Roosevelt School

# CHANGE ORDER

PROJECT: BAKERSFIELD CITY SCHOOL DISTRICT CHANGE ORDER NO: TWO (2)  
ROOSEVELT ELEMENTARY MODERNIZATION

ARCHITECT'S PROJECT NO: 88-142  
O.S.A. FILE NO.: 15-6  
O.S.A. APPLICATION NO.: A-51474  
O.L.A. APPLICATION NO.: 77/63321/0009  
(77/50609)

**SK**  
**6**

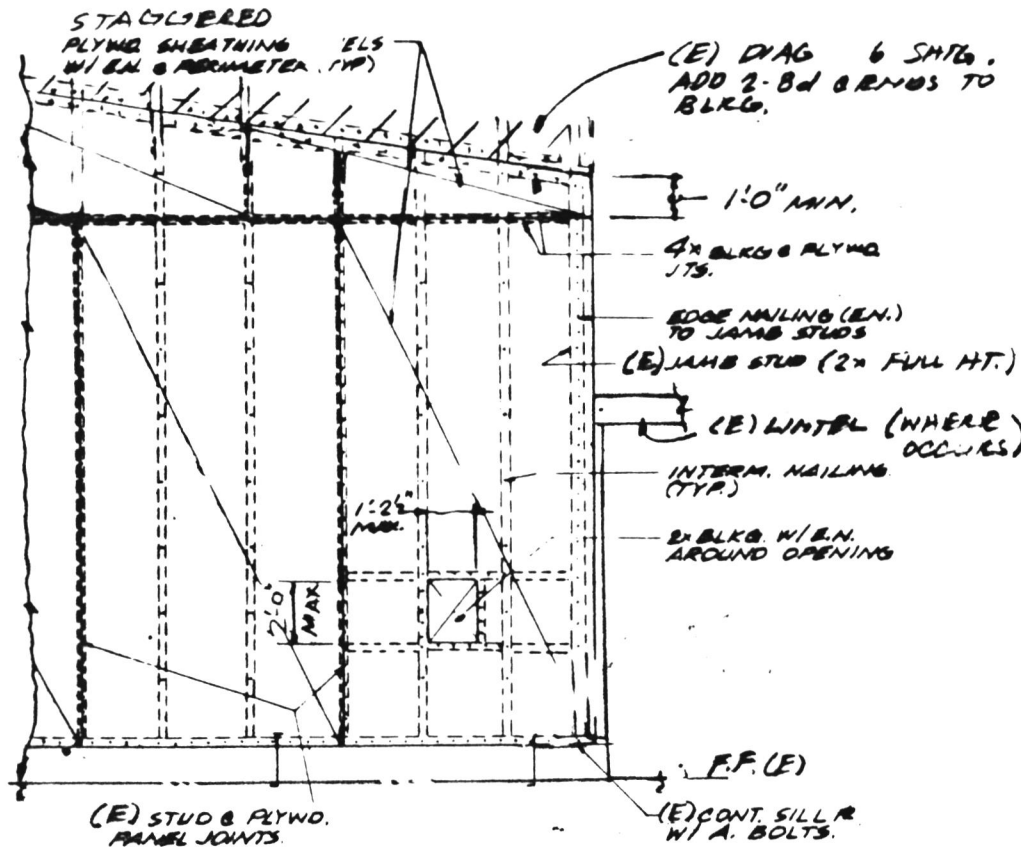
ITEM	DESCRIPTION	DEDUCT	ADD
1.	Provide isolation valves in the underground chilled water supply and return piping at Buildings 200, 300, 400, 500, and 600.	\$ 0.00	\$ 4,427.00
2.	Provide signal and alarm terminal cabinets at Building 200 and 400 as shown on attached drawing SK-6 (27 Jun 91).	\$ 0.00	\$ 1,109.75
3.	Provide interior plaster system on south wall of Room 121, Library.	\$ 0.00	\$ 1,443.00
4.	Provide beam support in Room 122, Conference, as shown on attached drawing SK-8 (23 Jul 91).	\$ 0.00	\$ 426.00
5.	Provide plywood shear wall on west wall of Room 401, Toilet, and 402, Toilet, to replace diagonal sheathing removed for plumbing, per attached drawing SK-7 (19 Jul 91).	\$ 0.00	\$ 1,495.00
6.	Provide nineteen (19) outside air louvers for unit ventilators in Buildings 200, 300, 400, and 500.	\$ 0.00	\$ 7,500.00

## TERMINAL CABINET MODIFICATION FOR ADDITIONAL TERMINATION SPACE DETAIL

NOTE: ABOVE DETAIL APPLICABLE AT BOTH EXISTING TERMINAL CABINETS.

SK  
8

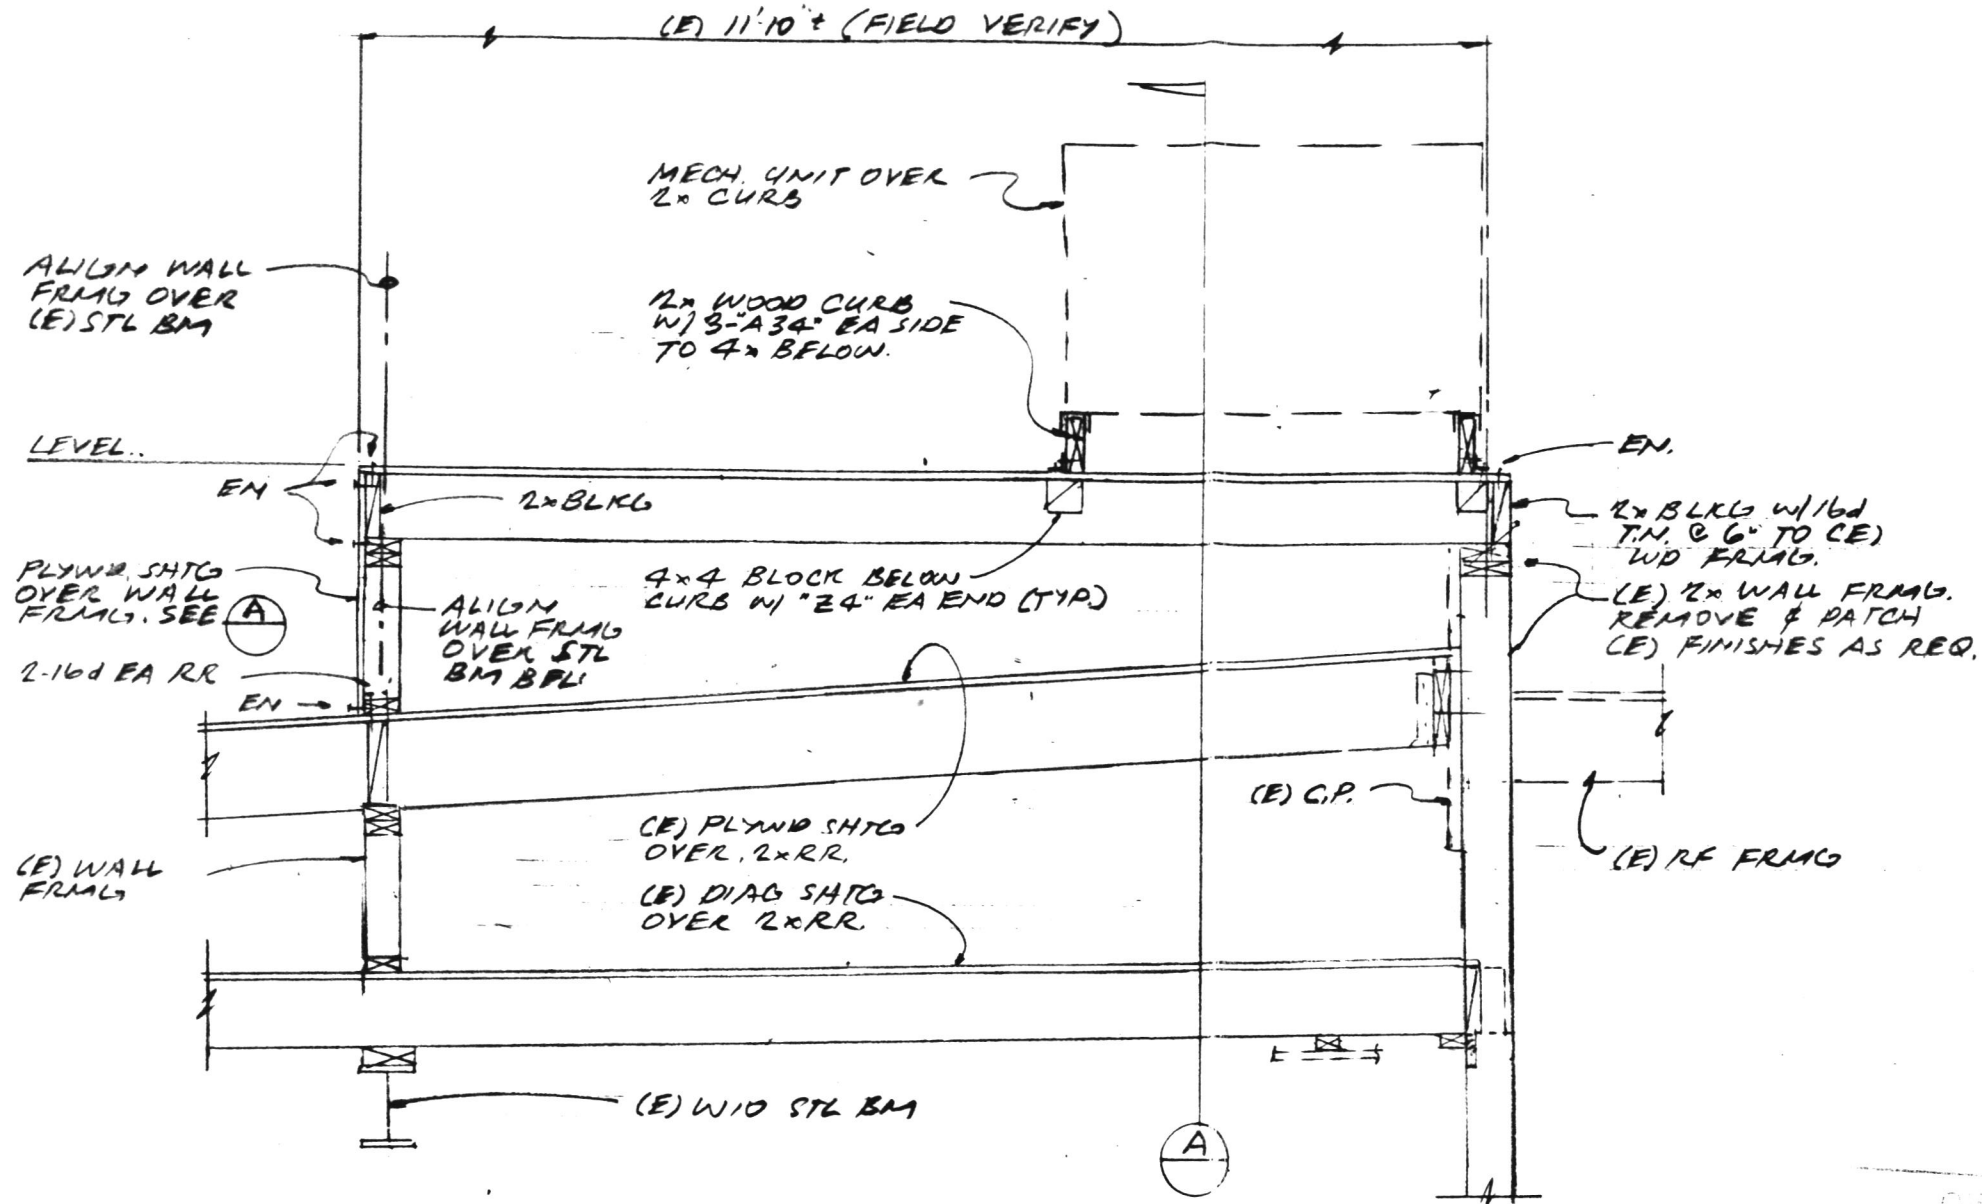
(E) BEAM ELEVATION STRENGTHENING 1/21-0'

(B) "6/S2.00 MODIFIED" 1/2" x 1'0"  
 NOTES 1. SEE (A) FOR NOTES.

BUDG 100 MECHANICAL PLATFORM  
 ROOSEVELT ELEM. MODERNIZATION  
 BAKERSFIELD CITY SCHOOL DISTRICT  
 OSA FILE NO. 15-6 OSA APPLICATION NO. A-51474

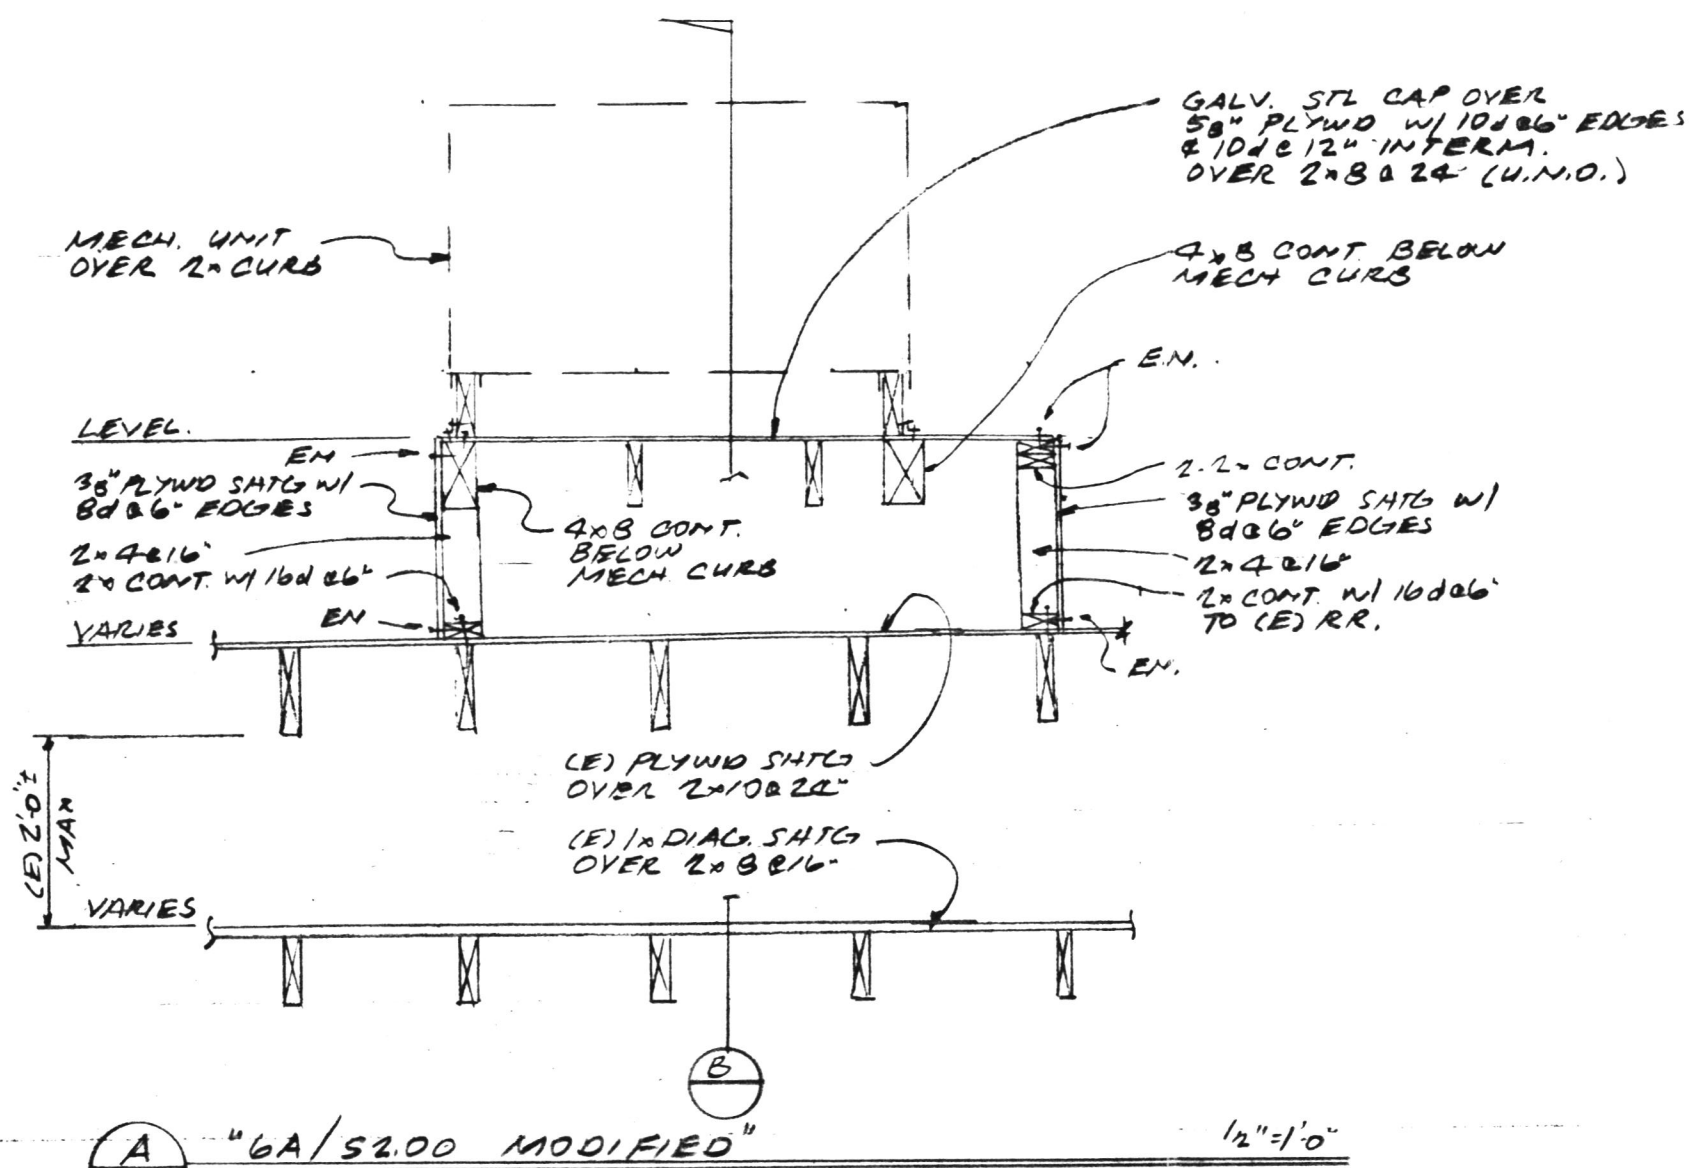
8.	Provide painting of 128 existing doors.	\$ 0.00	\$ 1,254.00
9.	Provide exposed ductwork and revised mechanical equipment platform as shown on attached drawing SK-9 (15 Aug 91) and SK-10 (15 Aug 91).	\$ 0.00	\$ 2,710.00

- NOTES:**
1. SEE APPROVED DRAWINGS & SPECS FOR LOCATION & ITEMS NOT SHOWN.
  2. ALL NEW WOOD FRMS SHALL BEAR DIRECTLY ON (E) WOOD SHTG OR FRMG. REMOVE (E) ROOFING & NON-STRUCTURAL ITEMS AS REQ FOR NEW WORK.
